Public Input No. 3085, Assigned to Code-Making Panel 1, Refer to Code-Making Panels 2 - 18

This Global Public Input is for all Technical Committees and review their informational notes and the requirements in the NEC Style Manual Section 2.1.10 for informational notes.

Committee: NEC-P01

Informational Note Figure 620.62 Selective Coordination for overcurrent protective devices supplying more than one elevator.

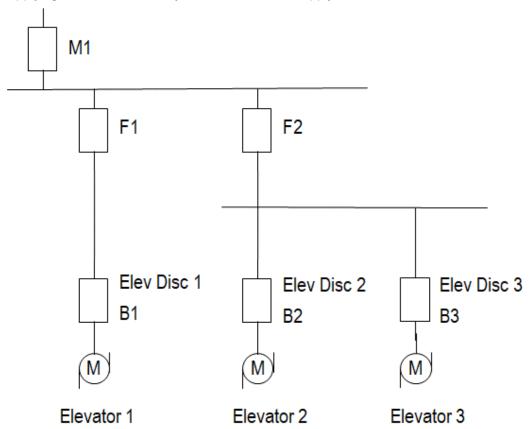
Informational Note: See Informational Note Figure 620.62 for an example of how OCPDs supplying elevators selectively coordinate with all supply-side OCPDs.

This public input clarifies that selective coordination needs to consider all overcurrent protective devices supplying elevators to assure an overcurrent condition will not result in loss of power to another elevator. An informational note and figure is added similar to that in NEC 700.32, 701.32 and 708.54.

620.62 Selective Coordination.

Where more than one driving machine disconnecting means is supplied by the same source, the overcurrent protective devices in each disconnecting means (OCPDs) supplying the driving machines shall be selectively coordinated with any other supply-side overcurrent protective devices OCPDs.
